TECHNICAL BULLETIN

MODEL/DERIVATIVE:
Freelander

Bulletin N°: 0016
CDS. ref: L8631bu
Issue: 1
Date: 10.01.2001

GEAR SELECTION PROBLEMS - VARIOUS

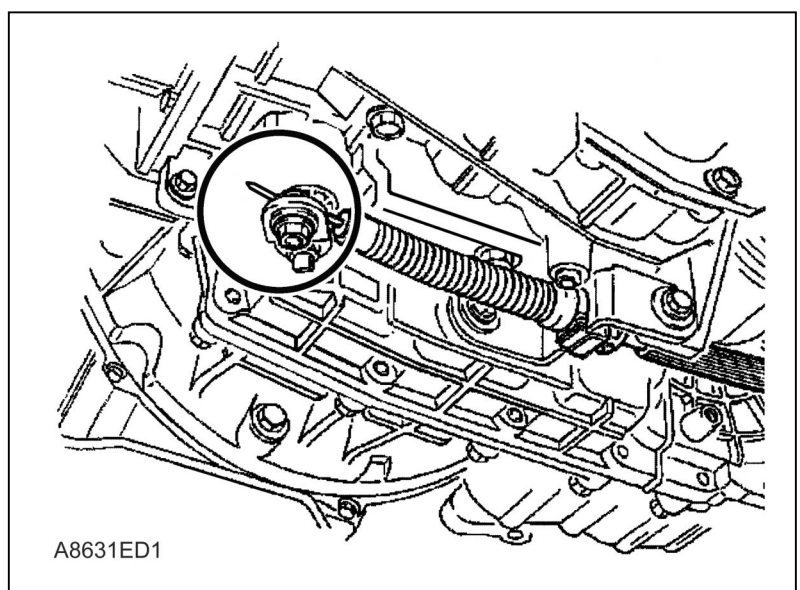
Automatic transmission selector cable incorrectly set.

Where a customer complaint including any of the above is confirmed, reset the selector cable using the revised procedure described below.

1. Remove underbelly panel, Workshop Manual repair number [76.10.50](#) refers.
2. Loosen trunnion nut securing inner cable to selector lever, (circled in illustration).
3. Move gear change lever into 'P' position. Push fully forward to ensure correct position and release lever.

4. Rotate selector lever on gearbox fully clockwise to engage 'P'.
5. Using pliers, pull the inner cable as far forward as possible and release.
6. Tighten trunnion nut to 6 Nm.
7. Refit the underbelly panel.
8. Move the gear change lever through its full range from 'P' to '2' and back to 'P', confirming that all gear positions are correctly selected.
9. Confirm that the engine will only start in 'P' and 'N' positions and is inhibited when all drive positions are selected.
